**TOWN OF MOUNTAIN VILLAGE
SPECIAL DESIGN REVIEW BOARD MEETING
AGENDA**

TO: Mountain Village Design Review Board

FOR: Special Design Review Board Public Hearing; February 11, 2021
(continued from February 4, 2021)

**1 ADDRESS MONUMENT - ELEVATION DETAIL**  
3/4" = 1'-0"

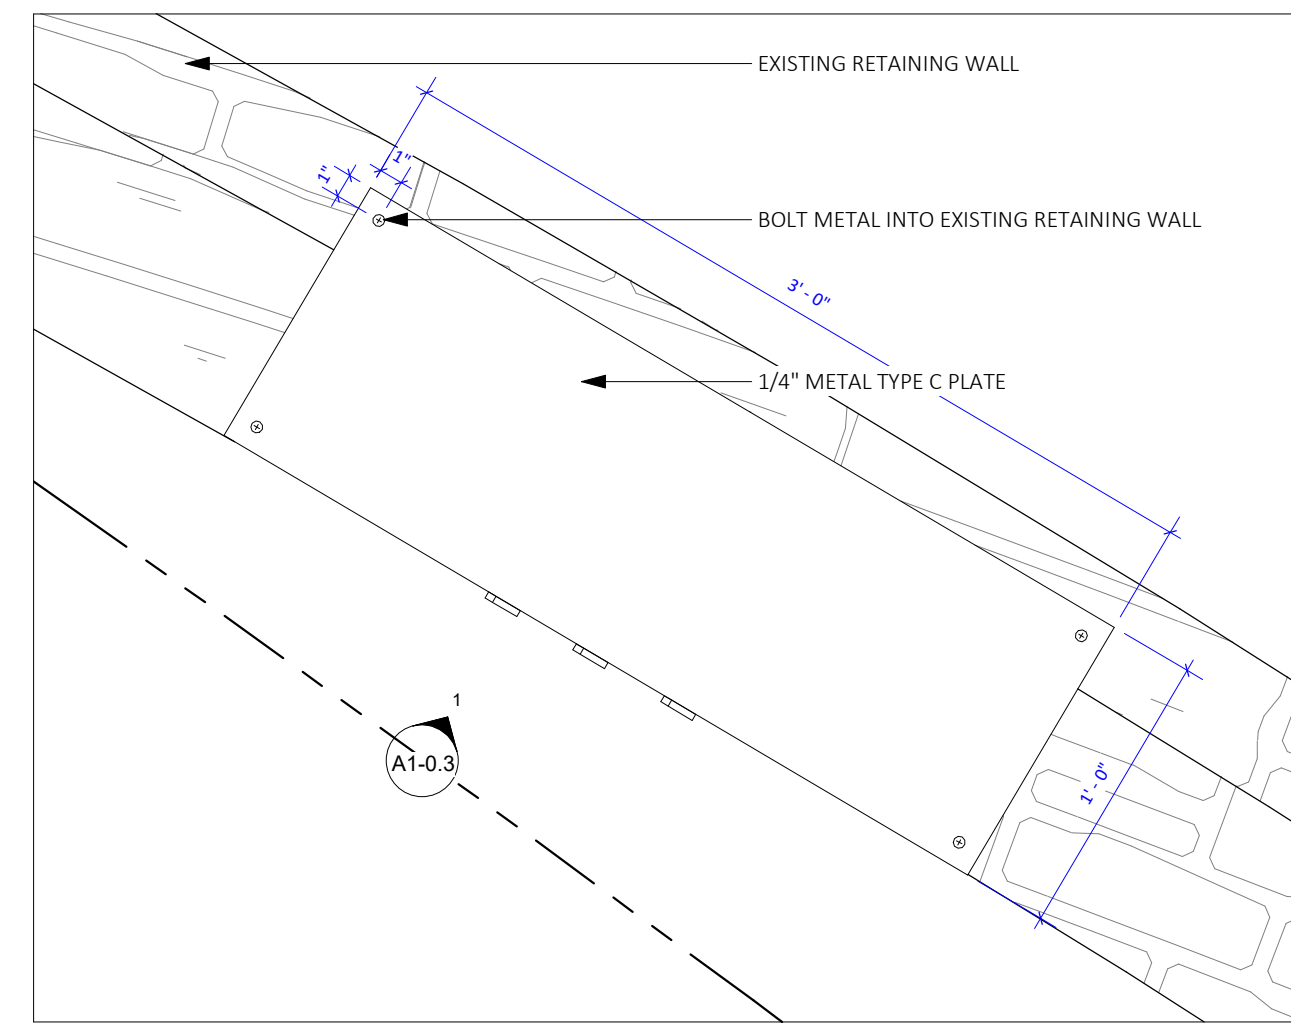
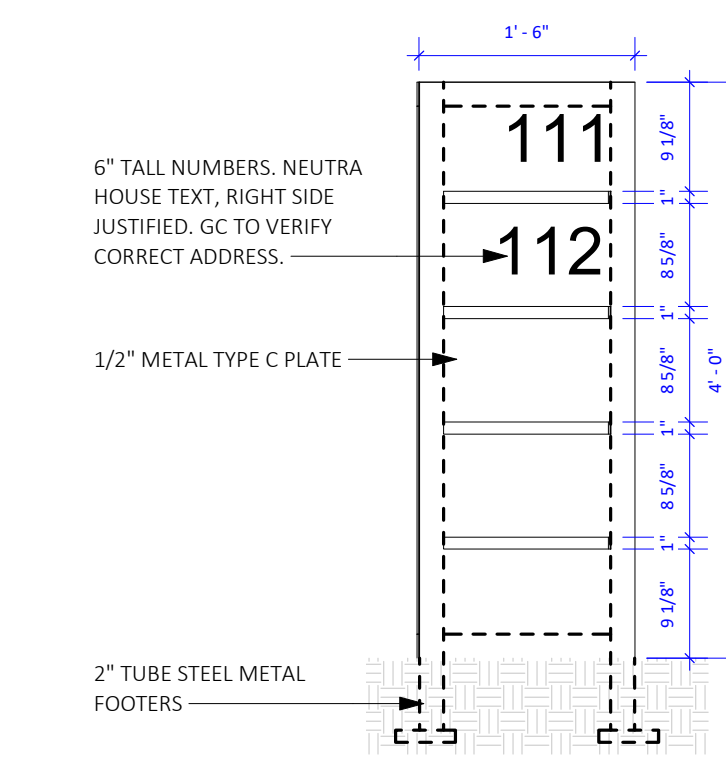
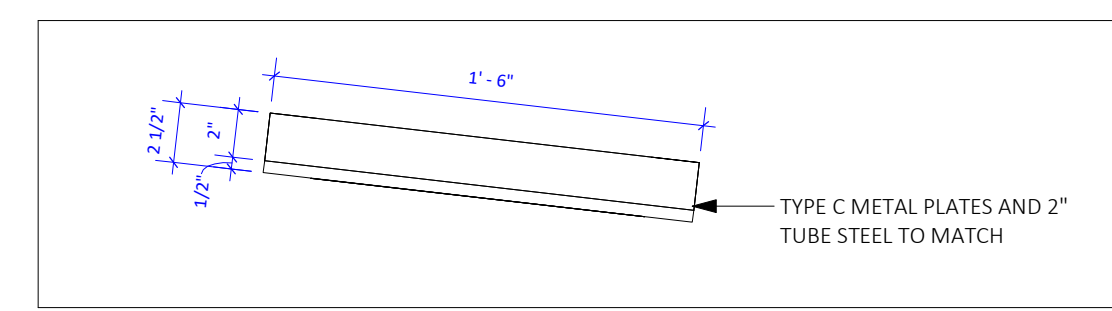
Staff: The applicant has indicated that the home will be addressed at a shared freestanding monument located at the beginning of the driveway as well as numbering located on the retaining wall of the home. The address numbering as shown in the plan set does not appear to be downlit, and more details should be provided surrounding the illumination of both the freestanding monument and the numbering on the retaining wall prior to final submittal.

- 1) Prior to submittal for a Final Architectural Review, the applicant shall revise the proposed address monument so the method of downlit illumination is demonstrated.
- 2) Prior to the submittal for a Final Architectural Review, the applicant shall provide
